CITY OF CONWAY, ARKANSAS PLANNING COMMISSION

February 16, 2021 • 7:00pm

Request for Preliminary Plat Approval - Miller's Creek Subdivision, Phase 2

Record No. SUB2021JAN03

CORRECTIONS NEEDED ON THE PLAT

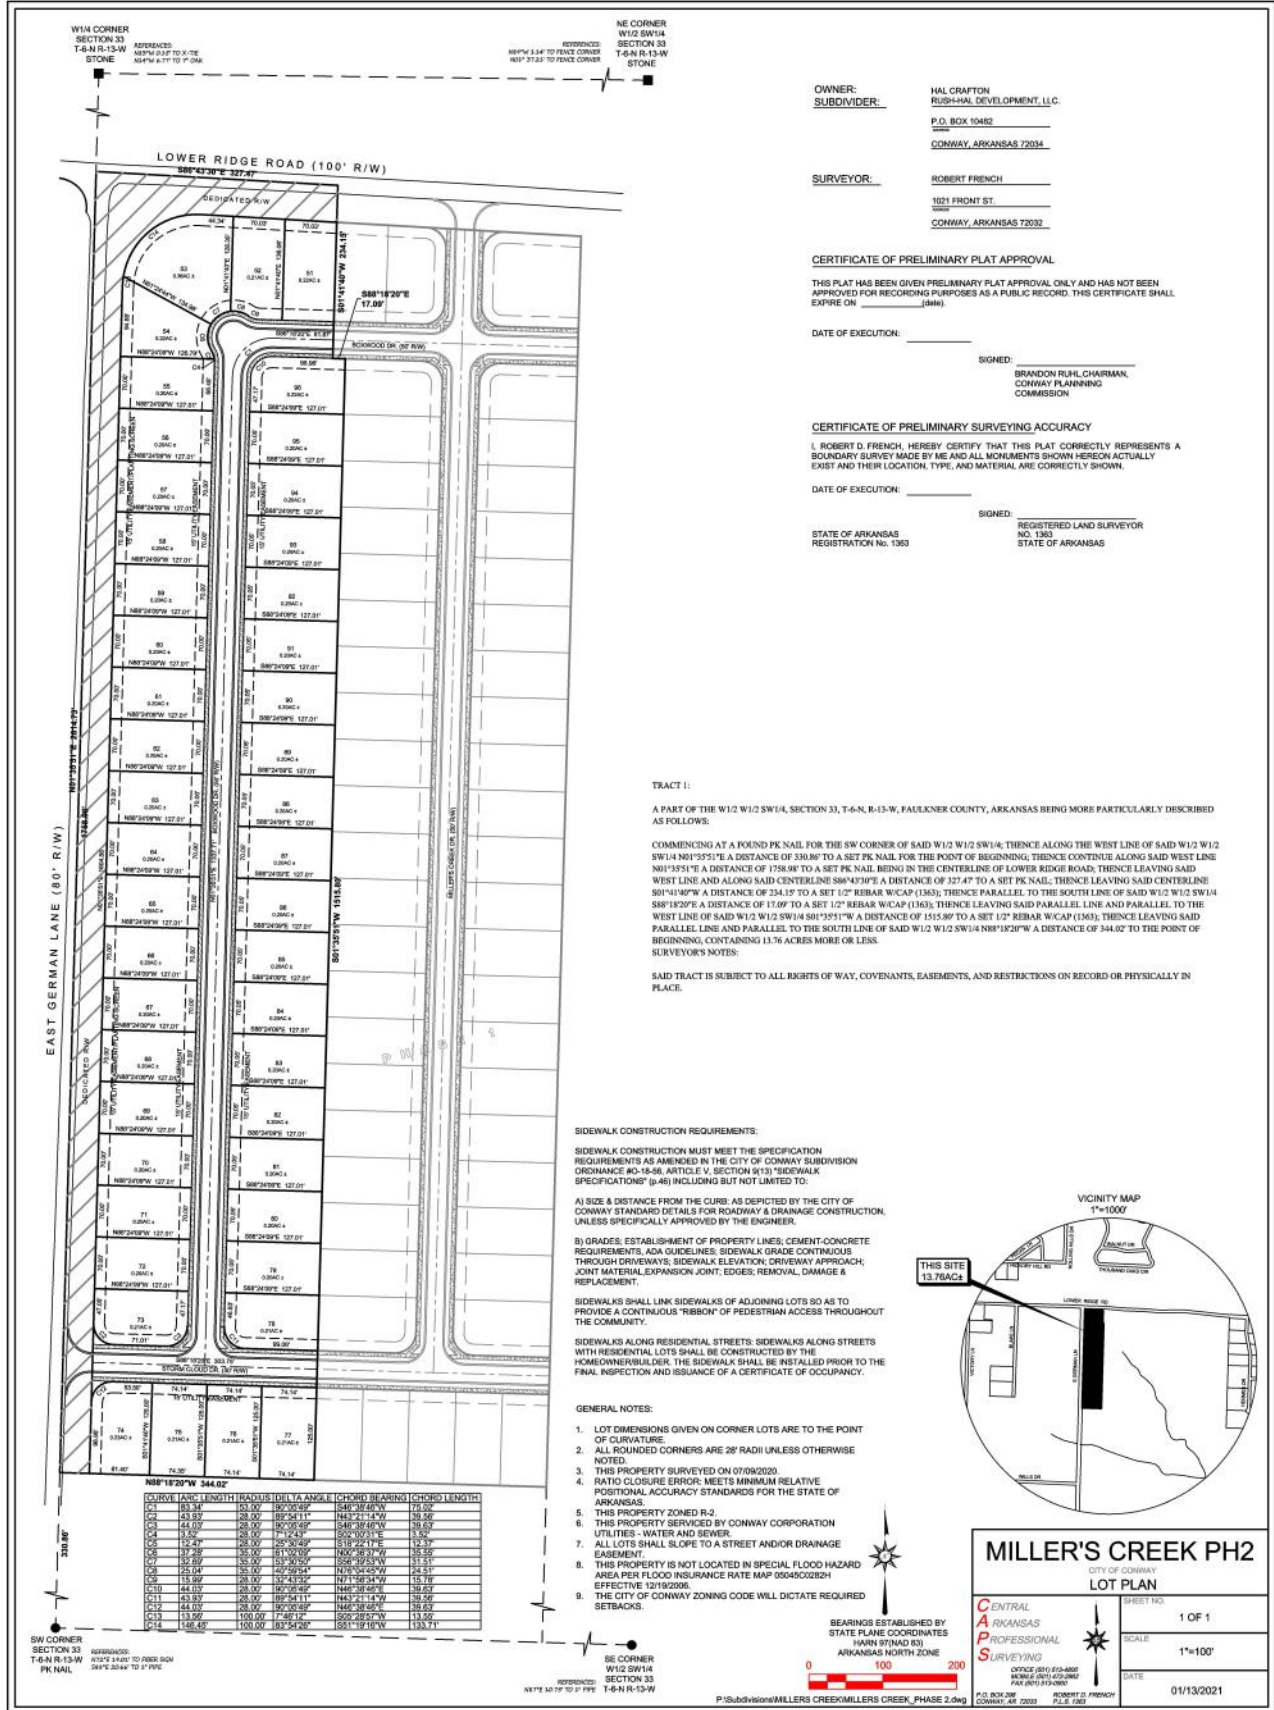
1. Show all hydrant locations.
2. Corrections as noted on Preliminary Plat.
